To: Savannah River Site Work Group and SEC Issues Work Group
From: SC&A, Inc.
Date: November 12, 2019
Subject: Review of NIOSH's Refined Construction Trade Worker Stratification Comparisons for Plutonium

Subsequent discussion of this report with the SRS work group in November and December 2017 (SRS WG, 2017, and ABRWH, 2017, respectively) noted that the subcontractor estimates appear to closely mirror or bound DuPont CTW estimates from 1976 through 1987. Significant differences were noted in 1977, 1979, 1985, and 1986. These discussions prompted NIOSH to pursue a more rigorous analysis comparing DuPont CTWs to subcontractor CTWs during this time period. NIOSH provided its updated analysis in the white paper, "Savannah River Site Plutonium Construction Trade Worker Stratification Refinement" (NIOSH, 2019b). This memorandum represents SC&A's review of that white paper.

Figure 1. NIOSH evaluation of plutonium urinalysis for DuPont construction trade workers, DuPont nonconstruction trade workers, and subcontractor construction trade workers from 1956 through 1988 (reproduced from NIOSH (2017))

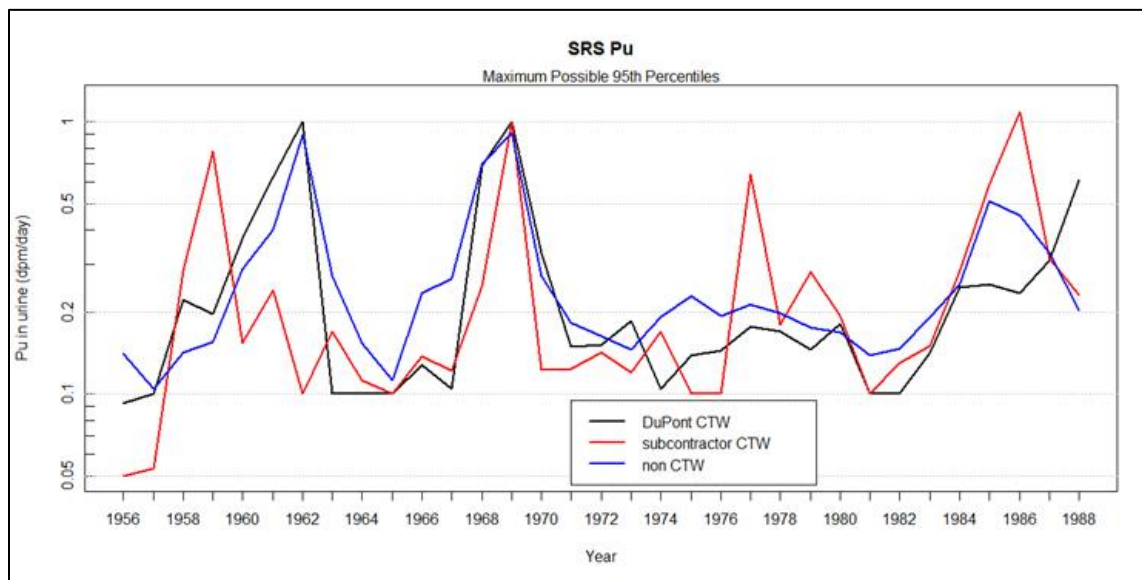
As noted in the previous section and in NIOSH (2019b), at the 95th percentile, the subcontractor CTWs had higher excretion rates and derived intakes than DuPont CTWs for the period 1979 through 1987. This is consistent with figure 1, which was originally produced by NIOSH and previously demonstrated that urinalysis results for subcontractor CTWs were either comparable to, or higher than, those of the DuPont construction workers. This is significant because the coworker model assignments for unmonitored construction workers have been proposed by NIOSH to be assigned at the 95th percentile (SRS WG, 2017, p. 27).

Finding 1: In SC&A’s opinion, the conclusion that subcontractor construction trade workers had higher excretion rates and derived intakes at the 95th percentile is significant from the standpoint of stratification because the 95th percentile is what is proposed for assignment to unmonitored subcontract construction workers.

Figure 2. NIOSH evaluation of the relative number of DuPont construction trade worker and subcontractor construction trade worker claimants monitored for plutonium from 1956 through 1988 (NIOSH, 2017)

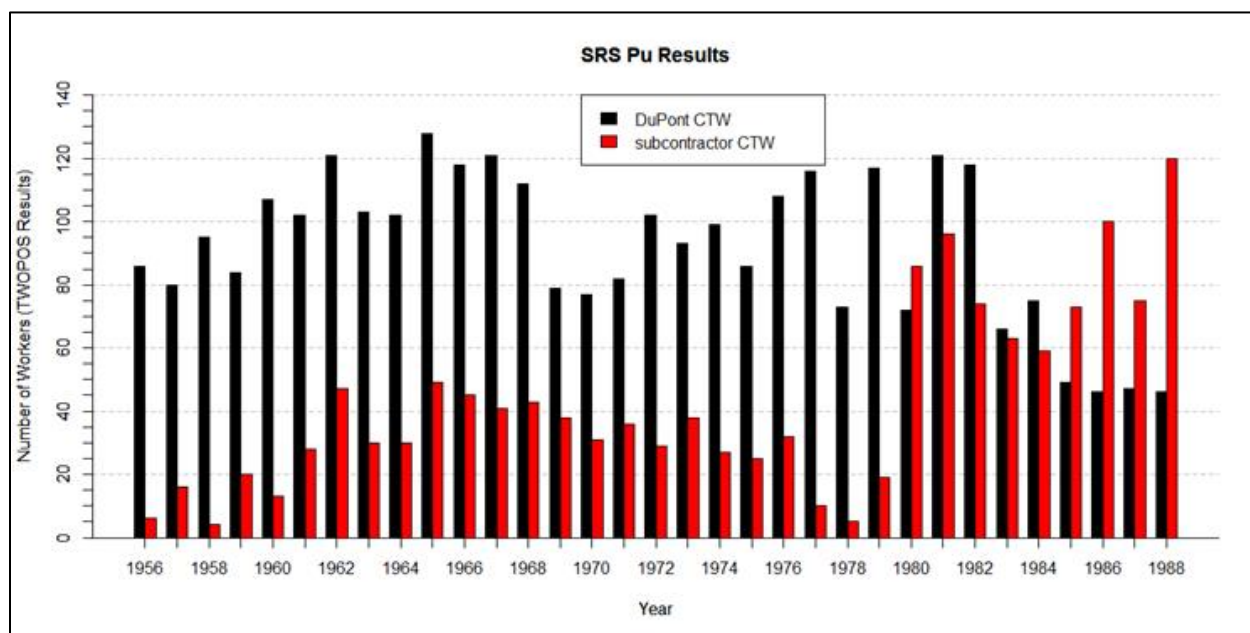
Furthermore, a tabulation of the relative number of monitored claimant subcontract construction trade workers by year versus claimant DuPont CTWs found in NIOSH (2017) shows a significant increase in the number of monitored subcontractors beginning in approximately 1980 (see figure 2, below). In addition, figure 5-1 (page 13) of ORAUT-RPRT-0094, revision 00, “Bioassay for Subcontractor Construction Trade Workers at the Savannah River Site from 1972 to 1997” (NIOSH, 2019c), also indicates a general increase in the number of claimant subcontract workers beginning in the late 1970s and into the 1980s (see figure 3). Therefore, SC&A believes the fact that subcontract workers exhibit higher urinary excretion rates at the 95th percentile of the distribution during this period is significant from the viewpoint of appropriate stratification.

Figure 4. Comparison of the actual dpm/disc and dpm/day data pairs against predicted dpm/day values for 1980

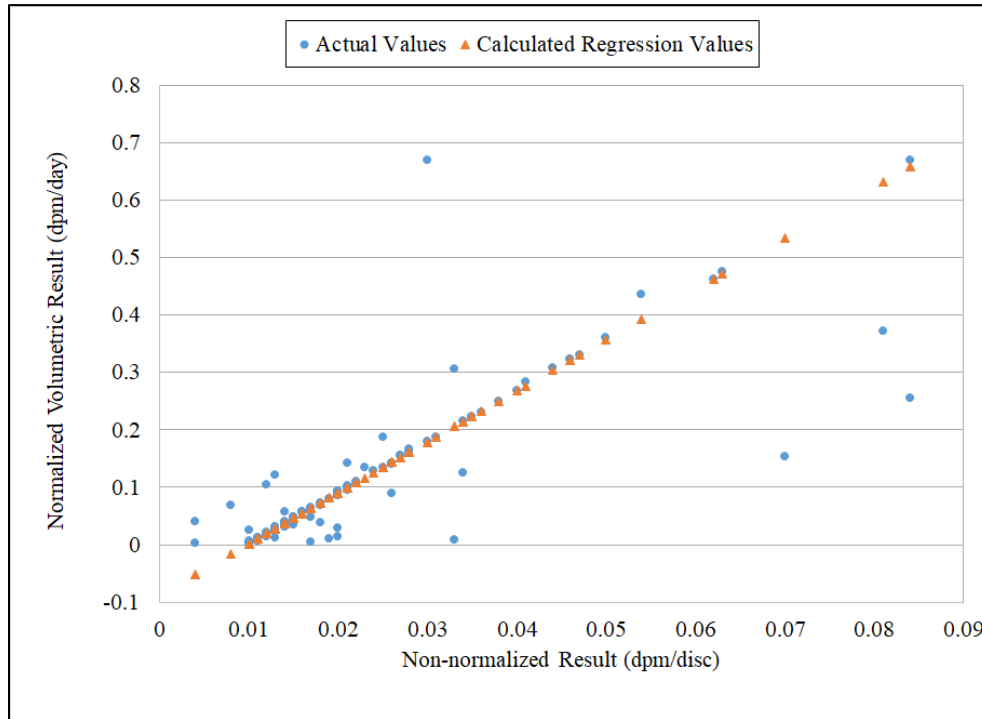
To further evaluate the accuracy of the regression formulas presented in NIOSH (2019b), SC&A compared the available measurement pairs (dpm/disc and dpm/1.5 L) in cases where both quantities were positive against the predicted result based only on the dpm/disc result and the associated regression formula. While some data pairs were predicted by the regression formulas with reasonable accuracy (especially at higher relative values), SC&A found that the regression analysis had a particularly poor fit for the years 1980 and 1986, as shown in figures 4 and 5.

Finding 4: The use of a regression analysis to convert raw bioassay results (dpm/disc) to a volumetric result (dpm/1.5 L) has not been technically justified and does not appear scientifically defensible.
